Contract #: 04-0120F4Cty: SF/ALA Rte: 80 PM: 13.2/13.9File #: 69.25B**QUALITY ASSURANCE -- NON-CONFORMANCE REPORT****Location:** Changxing Island, Shanghai, P.R. China**Report No:** NCR-000621**Prime Contractor:** American Bridge/Fluor Enterprises, a JV**Date:** 10-Jan-2010**Submitting Contractor:** Zhenhua Port Machinery Company, Ltd (ZPMC), Changxing Island**NCR #:** ZPMC-0594**Type of problem:**

Reference Description: Repair of cracks without CWR on Lift 12E Longitudinal Shear Plate**Description of Non-Conformance:**

Subject: NCR No. ZPMC-0594

Contract #: 04-0120F4Cty: SF/ALA Rte: 80 PM: 13.2/13.9File #: xx.25A**QUALITY ASSURANCE -- NON-CONFORMANCE RESOLUTION****Location:** Changxing Island, Shanghai, P.R. China**Report No:** NCS-000486**Prime Contractor:** American Bridge/Fluor Enterprises, a JV**Date:** 27-Jan-2010**Submitting Contractor:** Zhenhua Port Machinery Company, Ltd (ZPMC), Changxing Island **NCR #:** ZPMC-0594**Type of problem:**

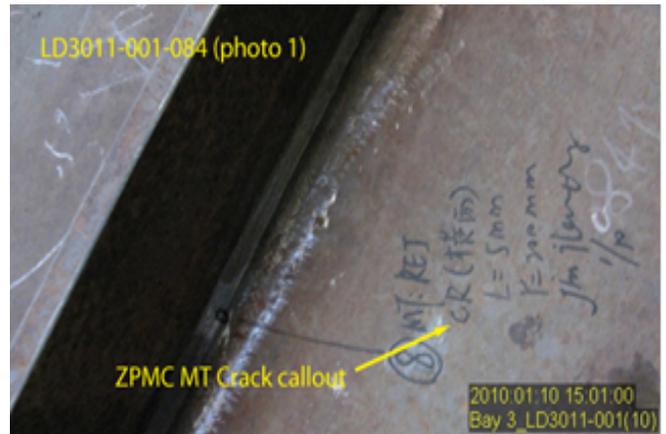
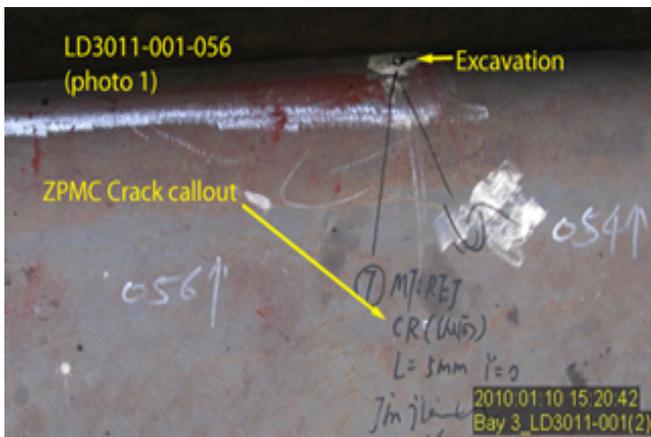
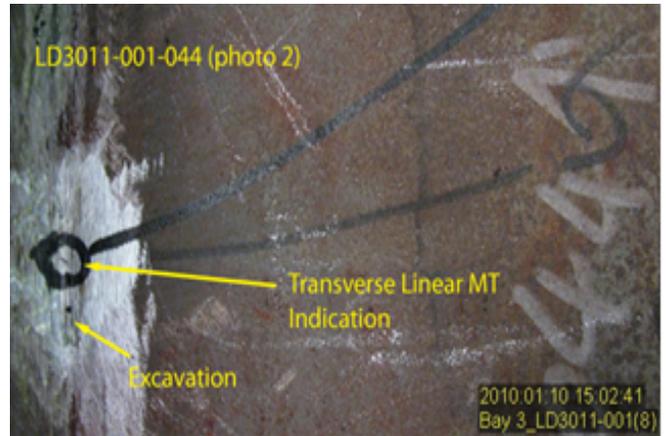
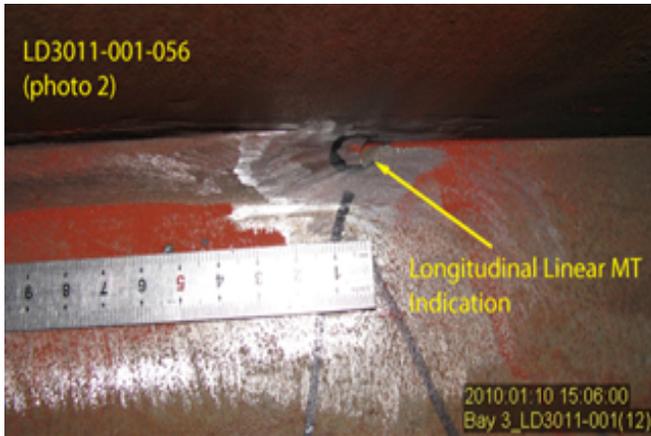
During random in process observations of the fabrication of longitudinal diaphragms in Orthotropic Box Girder (OBG) bay 3, this Quality Assurance (QA) Inspector observed the following issues:

- ZPMC Production Personnel excavating Linear MT Indications identified by ZPMC's MT Technician as cracks, without an approved Critical Weld Repair (CWR) for Lift 12E near working point E4.

- One (1) Longitudinal linear indication measuring approximately 5mm in length; Y location is identified as 0mm.
- The weld is identified as: LD3011-001-056.

- One (1) Transverse linear indication measuring approximately 5mm in length; Y location is identified as 200mm.
- The weld is identified as: LD3011-001-084.

- One (1) Transverse linear indication measuring approximately 9mm in length; Y location is identified as 650mm.
- The weld is identified as: LD3011-001-044.

- One (1) Transverse linear indication measuring approximately 9mm in length; Y location is identified as 1100mm.
- The weld is identified as: LD3011-001-078.

- These welds are all Fillet Welds joining Longitudinal Diaphragm Stiffeners to Longitudinal Diaphragm (LD3011A) web plate.
- The Longitudinal Diaphragm (Longitudinal Shear Plate) is located in the Sub-Assembly Bay 3.

Reference Resolution: The grinding was to determine if the indications found by MT were cracks or just slag inclusions or porosities. CWR is not required as it is still the exploratory phase of the process

The grinding observed was to determine if the indications found by MT were cracks or just slag inclusions or porosities. If the indication is then determined to be a crack, a CWR will be issued. If the indication is removed and does not require subsequent welding, a CWR is not required as no weld repair was performed. If the indication is not interpreted to be a crack, such as slag, undercut, overlap or lack of fusion, basically an indication that holds powder, a WRR will be generated for welding repair. In this case a CWR is not required as it is still the exploratory phase of the process and not a repair or excavation. Since the basis of the NCR was "ZPMC Production Personnel excavating Linear MT Indications identified by ZPMC's MT Technician as cracks, without an approved Critical Weld Repair (CWR) for Lift 12E near working point E4." ABFJV/ZPMC requests that this NCR be closed because this was not an excavation.

The Engineer has reviewed the information provided in the NPR. The indication found turned out to be a crack and it has been repaired with an approved CRW. NDT has also been done to show that the repair was successful. Please be aware that a CWI must be present with an approved CWR and preheat must be applied prior to excavating cracks.

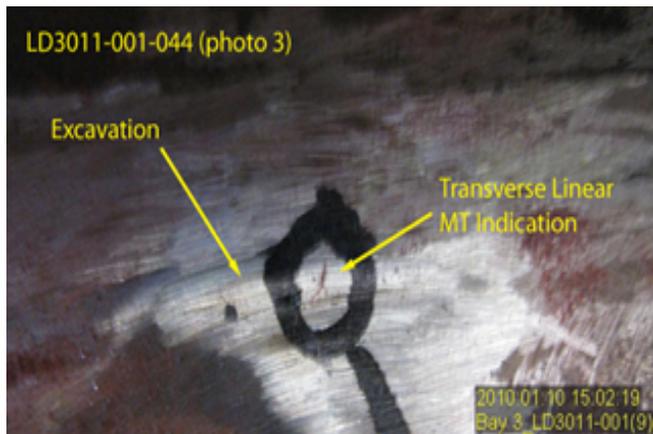
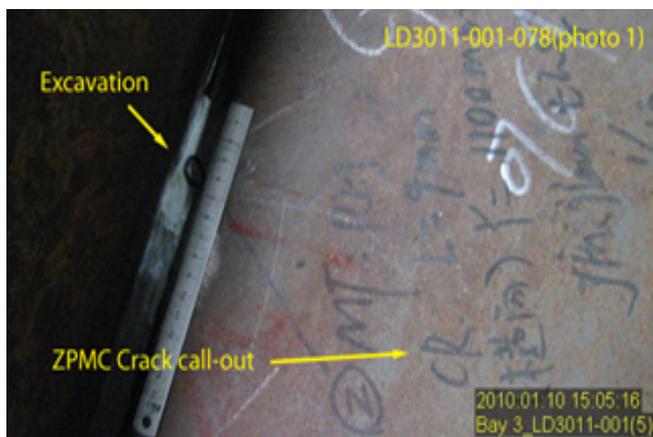
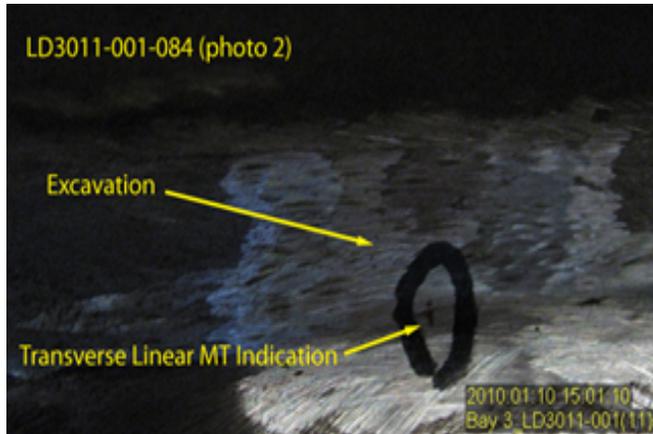
Special Provisions Section 8.3 – “Quality Control (QC) shall be the responsibility of the Contractor. As a minimum, the Contractor shall perform inspection and testing of each weld joint prior to welding, during welding, and after welding as specified in this section and to ensure that materials and workmanship conform to the requirements of the contract documents.”

Special Provisions Section 8-3; The Engineer shall be notified in writing when welding problems, deficiencies, base metal repairs, or any other type of repairs not submitted in the WQCP are discovered and also of the

AWS D1.5-2002 Section 3.7.4; Prior approval of the Engineer shall be obtained for repairs to base metal, repairs of major or delayed cracks.

ZPMC WQCP section 9 - 9.2.1.2 "Prior approval of the Engineer shall be obtained for repairs to base metal other than what was identified in section 9.2.1.1 of this manual and the repair of all other cracks."

The Contractor is of the opinion that this NCR was written while ZPMC personnel was in process of determining the severity of the indication. ZPMC production personnel stopped work after being notified of the Non Conformance. A CWR was approved for the repair and the weld has since been Green Tagged
